Work Order ID 100016

Item Name: Crosstube Aft

DRAWING NO. D206-667-243	TITLE CROSSTUBE ASS'Y (206L HIGH AFT)	REV. C	DART AEROSPACE LTD ENGINEERING ORDER		D.E.O. NO D206-667-243-C-1	SHEET NO. SHEET 1 OF 1	SCALE NTS
DRAWN 9	CHECKED A.S.S.	MFG. APPR. R.B.	APPROVED M.P.		DE APPR. H		
DATE 11.07.15	DATE 11.07.20	DATE 11.07.21	DATE 11/07/21		DATE 11.07.21

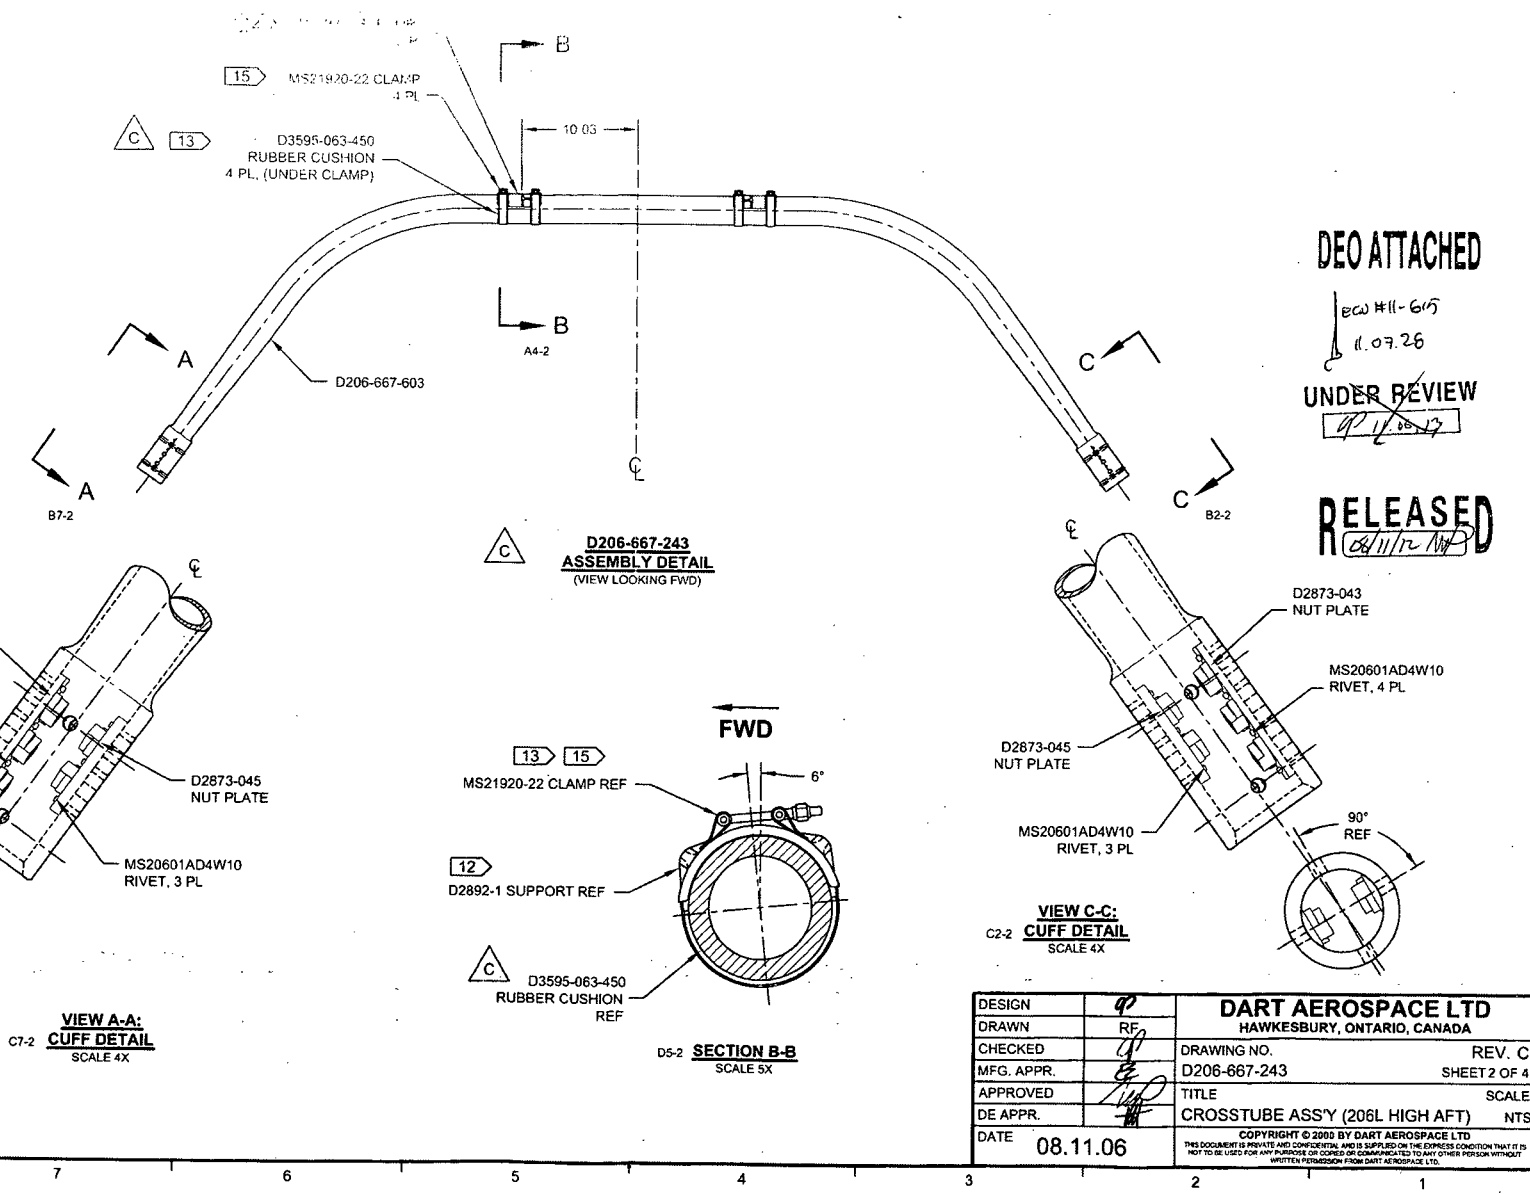
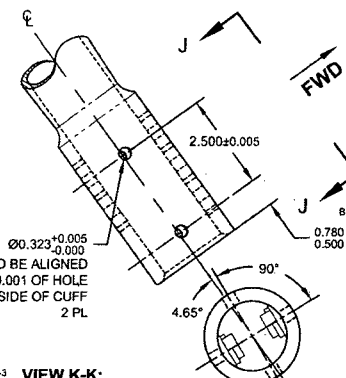
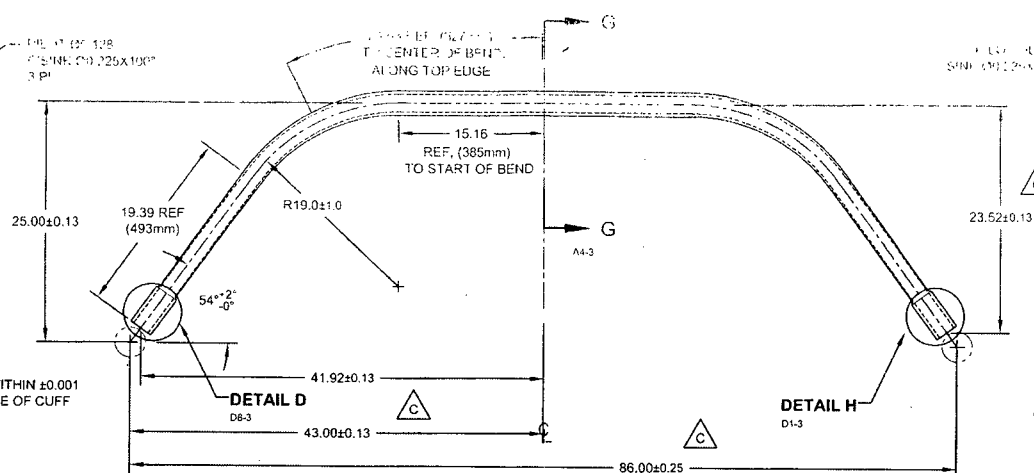
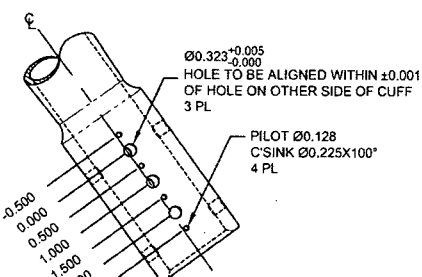
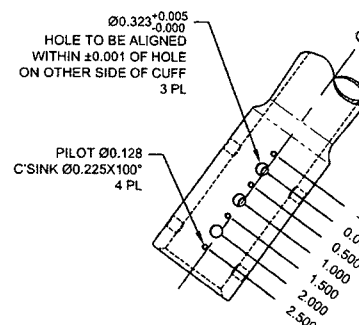
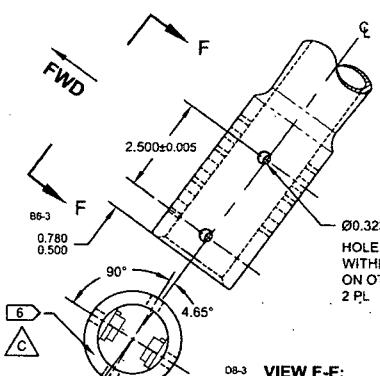
REPLACE MAGNOBOND WITH PROSEAL.

NOTE 12 & 15, SHEET 1 IS AMENDED AS FOLLOWS:

- 12) TO INSTALL D2892-1 SUPPORT: ABRABE MATING SURFACE OF SUPPORT AND CROSSTUBE WITH 180-GRIT SANDPAPER AND REMOVE RESIDUE WITH MEK (OR EQUIVALENT). APPLY A 0.04" TO 0.07" THICK LAYER OF PROSEAL 890 CLASS B-2 (OR AMS-S-8802 CLASS B-2) SEALANT TO MATING SURFACE OF SUPPORT.
- 15) TORQUE CLAMPS 80 TO 100 IN-LB. ENSURE AT LEAST 1.5 THREADS SHOWING IN SAFETY AND THAT NUT HAS NOT BOTTOMED-OUT AFTER TORQUING. PRIOR TO PACKAGING, RE-CHECK TORQUE ON CLAMPS AFTER PROSEAL 890 SEALANT HAS CURED FOR 72 HOURS.
